File No: G-17295

PUBLIC INTEREST REVIEW FOR GROUND WATER APPLICATIONS

SUBJECT: Application G- 17295 Supersedes review of N.A.
Date of Review(s)

A. GENERAL INFORMATION: Applicant's Name: U.S. Bureau of Land Management County: Klamath

Transient Stream Depletion (Jenkins, 1970; Hunt, 1999)

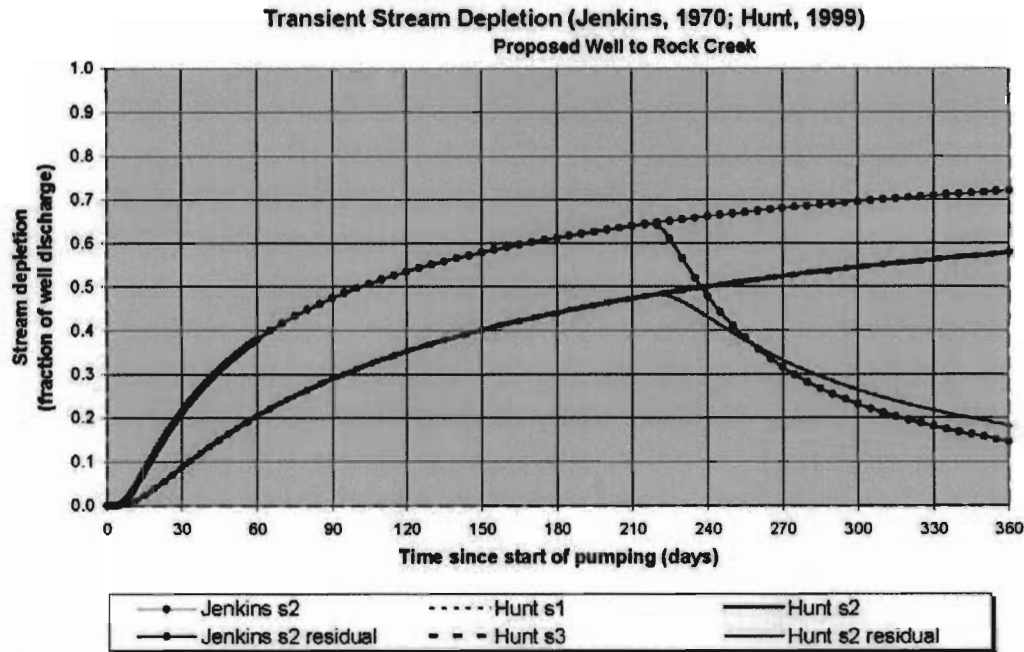
The Hunt (1999) model was used to calculate interference with Rock Creek given little to no sediment overlies the basalt on the lava "plateau" depending on location. Sediment is likely present in the vicinity of the stream.

The Hunt (1999) used a transmissivity of 2,000 ft²/day; a storage coefficient of 0.001 (an intermediate value); streambed conductivity of 0.20 ft/day (1/100 of the aquifer conductivity); and a streambed thickness of 10 feet. The transmissivity was derived from specific capacity data for well KLAM 54689 located on the lava "plateau" near Gerber reservoir. Other wells on the "plateau" with water well reports did not have specific capacity data. Like the proposed well, well KLAM 54689 is located where the ground water gradient is steep toward the valley to the west. The transmissivity of 2,000 ft²/day is much lower than the 600,000 ft²/day estimated for south Langell Valley (see Grondin, 2004). This difference is considered appropriate given the much steeper ground water gradient in the vicinity of the proposed well and the much flatter gradient within south Langell Valley.

Proposed Well to Antelope Creek/East Br Lost River

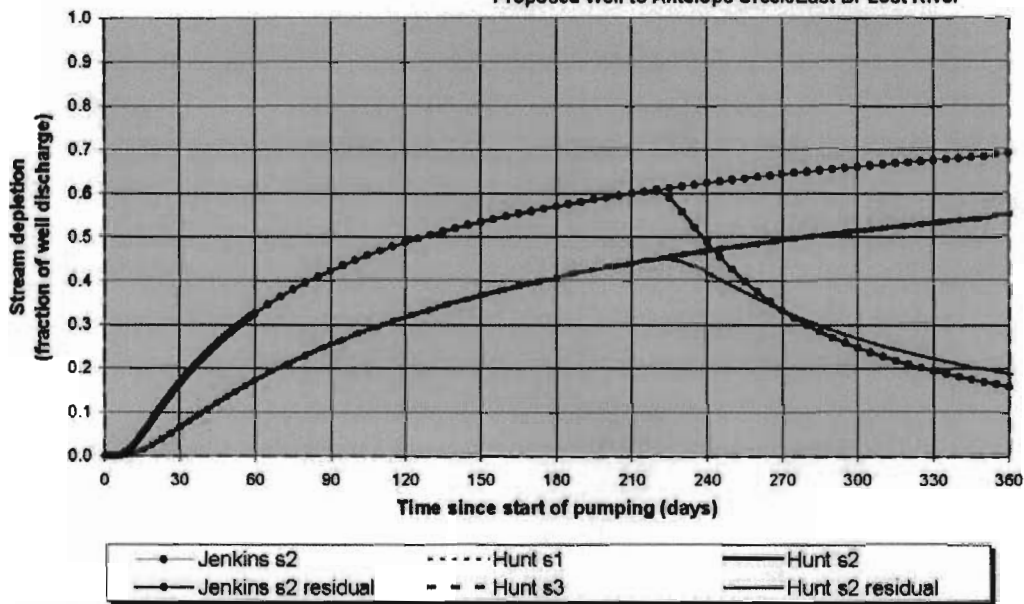
The Hunt (1999) model was used to calculate interference with Antelope Creek/East Branch Lost River given little to no sediment overlies the basalt on the lava "plateau" depending on location. Sediment is likely present in the vicinity of the stream.

The Hunt (1999) used a transmissivity of 2,000 ft²/day; a storage coefficient of 0.001 (an intermediate value); streambed conductivity of 0.20 ft/day (1/100 of the aquifer conductivity); and a streambed thickness of 10 feet. The transmissivity was derived from specific capacity data for well KLAM 54689 located on the lava "plateau" near Gerber reservoir. Other wells on the "plateau" with water well reports did not have specific capacity data. Like the proposed well, well KLAM 54689 is located where the ground water gradient is steep toward the valley to the west. The transmissivity of 2,000 ft²/day is much lower than the 600,000 ft²/day estimated for south Langell Valley (see Grondin, 2004). This difference is considered appropriate given the much steeper ground water gradient in the vicinity of the proposed well and the much flatter gradient within south Langell Valley.
